Revised Staff Report for the Hearing Examiner

Permit Number: 16 05551

Project Name: Central Kitsap High School and Middle School Replacement

Type of Application: Conditional Use Permit

Figure 3 Topographic section from the football field toward the east and north property lines

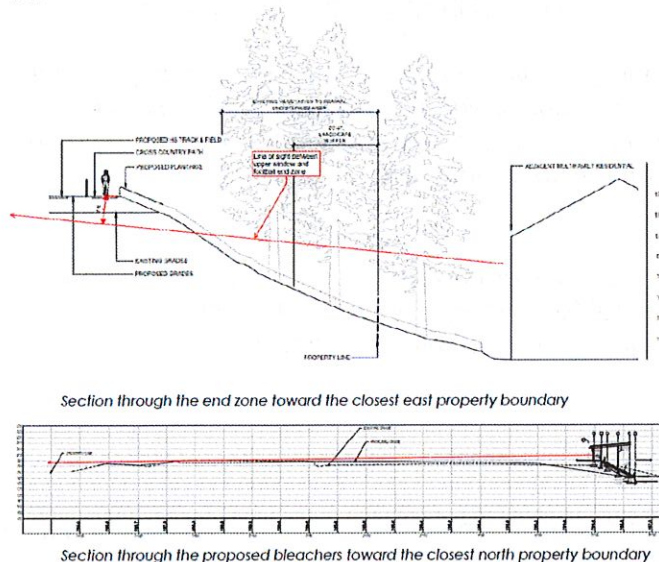
The field orientation, with the seating facing south, and the district's plan to cover the bleachers will, prevent noise emanating all directions to help mitigate impacts to abutting dwelling along the north property line at the same elevation. Staff agrees that the topography will break the line of sight for sound travel for the abutting multi-family housing, but the next row of units may be impacted. Staff generally supports the finding in the noise study, however staff has conditioned the project through SEPA to require that the applicant prepare a follow-up event noise study to verify that there is proper compliance.

Figure 2 Noise sources including cars and buses (gray), building mechanicals (school buildings) outdoor activities (yellow), and sporting events (l on the project site plan

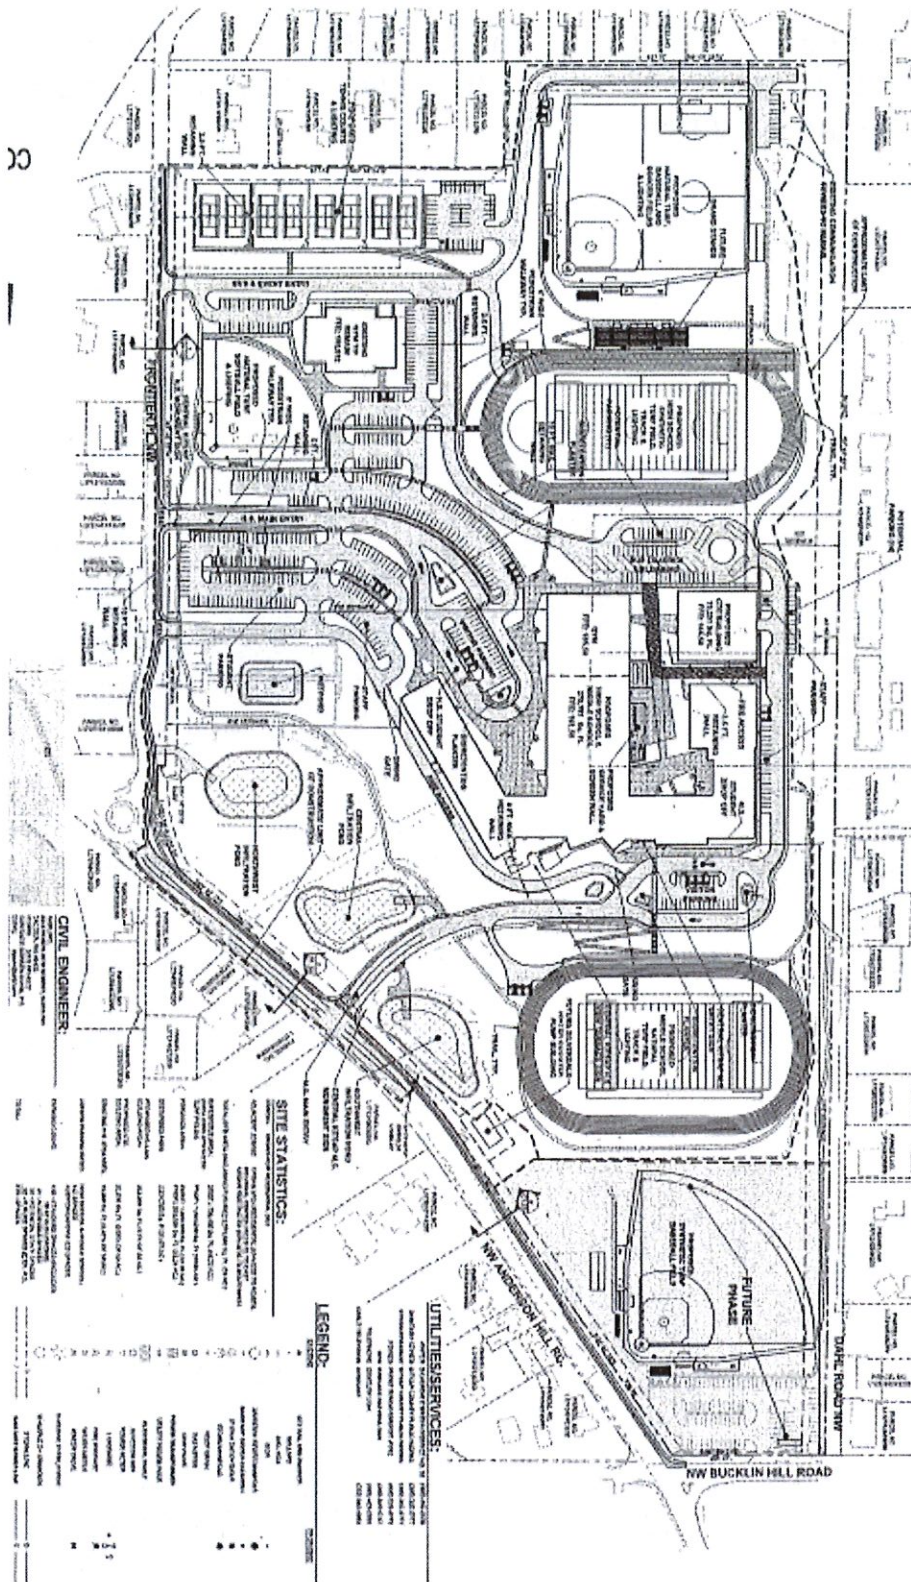
The Department reviewed the project for consistency with the above noise standards. The School District had a noise impact study prepared by a noise consultant, dated March 14, 2017 (Exhibit 20). Activities will occur within the interior of the school facilities and outside on the campus. The associated outside activities include auto mobiles and buses maneuvering on the school grounds, building mechanical equipment and sporting events that will occur at the outdoor fields (football, Soccer , baseball/softball, tennis) and outdoor student noise from PE classes and other student related outdoor activities. The school district is proposing to change the designation of the existing football field from practice-only facility to a practice and competition venue and construct seating for up to 1,500 people. The sporting events will include

crowds, yelling voices, whistles, marching bands, and a public address system. Chapter 10.28.040 states the noise limitations at the east property line 57dBA at the property line. Some literature indicates that noise levels could exceed 100 dBA for sporting events. The District's noise consultant believes that the topography will play a mitigating factor to reducing the noise impacts for adjacent residential dwellings.
